**SB-10058068-6980**

**FORD:**  
2015 F-150

Some 2015 F-150 SuperCrew vehicles built on or before 4/27/2015 and equipped with a rear seat center armrest may exhibit a concern where the armrest does not stow flush with the rear seat back.

Figure 1 - Article 15-0080

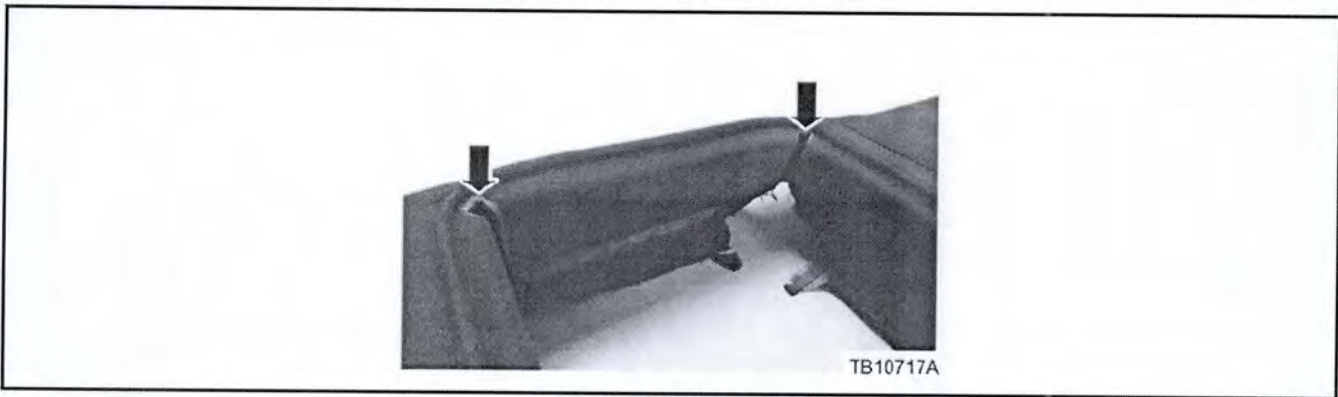
1. Inspect the rear seat center armrest to be sure the stowage pocket is clear of obstructions and verify the concern.
2. Remove the left hand (LH) rear seat backrest cover and foam pad. Refer to the Workshop Manual (WSM), Section 501-10.
3. Using a razor blade or similar tool cut two 10 mm x 10 mm x 100 mm (13/32" x 13/32" x 4") trenches into both upper corners of the armrest pocket in the rear seat backrest foam pad. (Figure 1)

- a. Do not cut into the surrounding foam bead.
4. Replace the LH rear seat backrest cover with the latest level service part, reusing the modified foam pad. Refer to the WSM, Section 501-10.
